To: Kristopher Byrd, Well Construction Section Manager
From: Tommy Laird, Well Construction Program Coordinator
Subject: Review of Water Right Application G-19186
Date: February 23, 2024

Groundwater Application Review Summary Form

Application # G- 19186

TO: Water Rights Section Date 3/25/2022
FROM: Groundwater Section Stacey Garrison/Travis Brown
SUBJECT: Application G- 19186 Supersedes review of

Water-Level Measurements in Nearby Wells

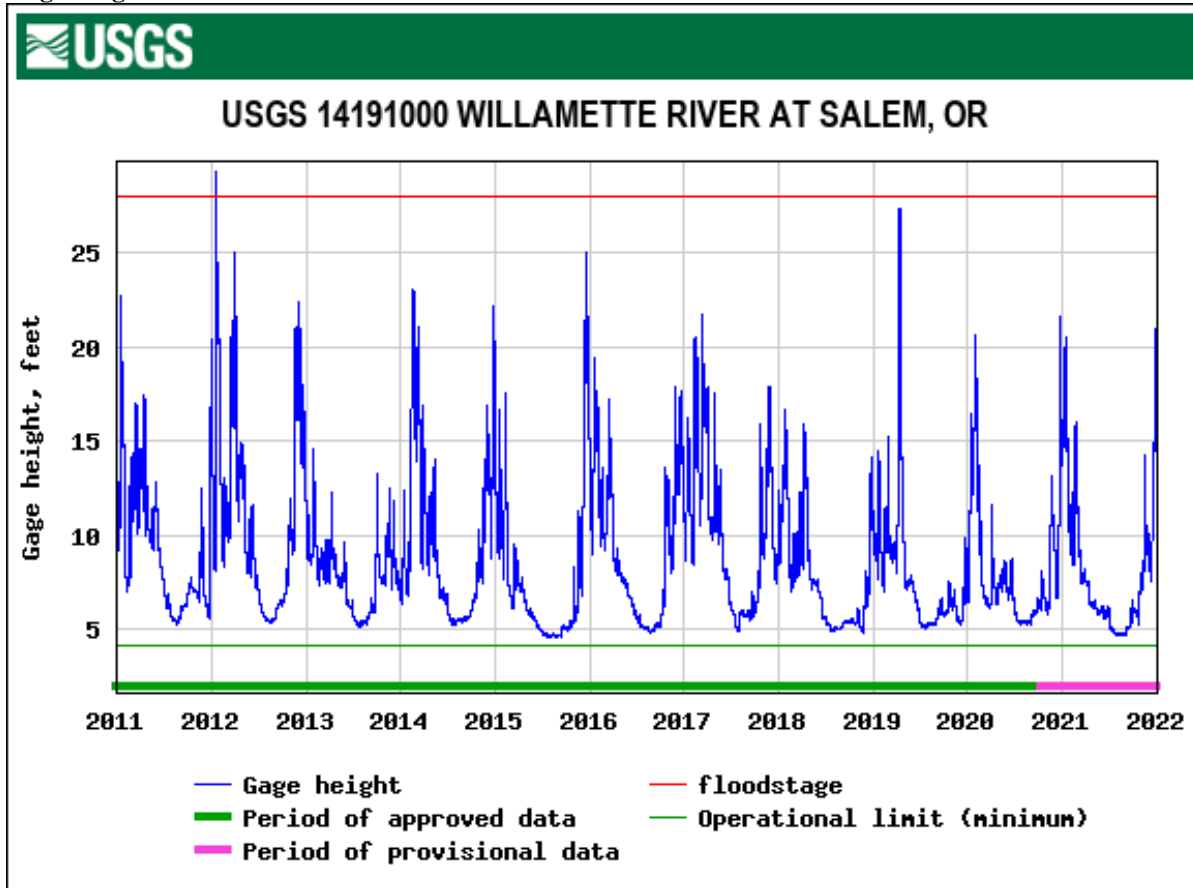
Water level trends for nearby (0.2 to 2 miles from POA) wells that utilize alluvial aquifers appear to be stable (see [Water Levels Measurements in Nearby Wells](#)). All the selected wells are located on Holocene floodplain deposits, nearly all with water levels within 10 feet of the elevation of the Willamette River. Two of the wells have water levels that are 15 to 20 ft above the Willamette River elevation recorded in the LiDAR dataset, however, these higher well readings are taken in the early spring when the Willamette River is elevated, whereas the LiDAR elevation was likely recorded in the summer when the river is at its lowest (see [Gage Height for USGS 14191000](#)). Water levels in the Holocene floodplain deposits are closely tied to the stream stage of the Willamette River (Conlon et al 2005). As a result, groundwater levels in the Holocene floodplains deposits are anticipated to be stable in the long-term, but seasonal fluctuations may be pronounced, particularly in late summer (see [Gage Height for USGS 14191000](#)). It appears that the proposed use is within the capacity of the resource. The nearest groundwater user to Well 1 that is not on the same taxlot is MARI 5330 (POA for multiple certificates, oldest priority date on Claim GR 368 12/31/1968), with an estimated location 1,060 ft south of the POA, at an elevation of ~117 ft msl. MARI 5330 is completed to a depth of 46 ft bls (71 ft msl). It is likely the proposed use would cause some degree of well-to-well interference with MARI 5330. To assess the degree of drawdown, a Theis drawdown analysis was conducted for the proposed use (see [Theis Drawdown Analysis](#)). Results indicate that the proposed use is not likely to cause well-to-well interference with MARI 5330 that exceeds the threshold under the standard condition for alluvial aquifers in the Willamette Basin.

Theis Drawdown Analysis

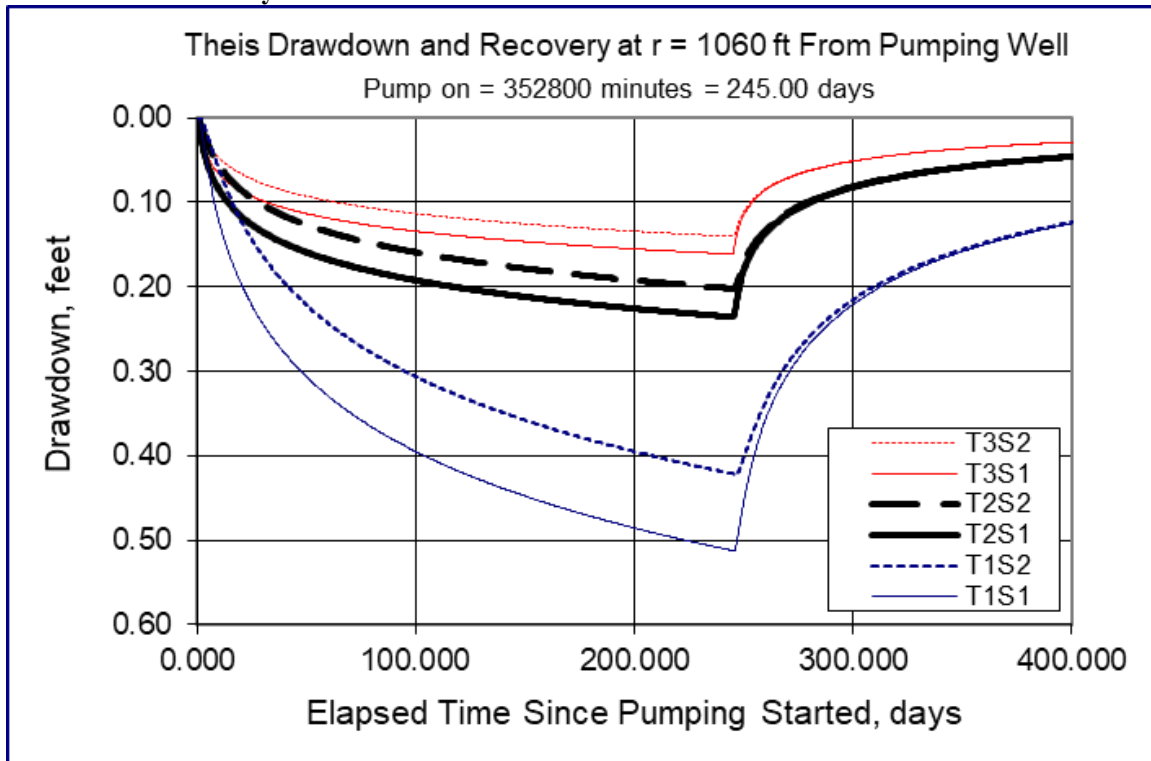
Radial distance from pumping well (r)=1,060 ft [estimated radial distance to nearest user, MARI 5330]

Pumping Rate (Q)= 0.272 cfs (~122 gpm) *

Aquifer Transmissivity (T1)= 104,720 gpd/ft (14,000 ft²/day), (T2)= 287,045 gpd/ft (38,375 ft²/day), (T3)= 460,020 gpd/ft (61,500 ft²/day)

Storativity (s1) = 0.15, (s2) = 0.30 [Heath 1983 and Morris & Johnson 1967, values for specific yield in gravel and sand]

Total pumping time = 245 days

*The full pumping rate could not be utilized continuously for the entire 365-day period of use without exceeding the 132.25 ac-ft maximum allowed duty. For the maximum allowed duty of 132.25 ac-ft, continuous pumping would occur for 245 days at a rate of 0.272 cfs (~122 gpm).
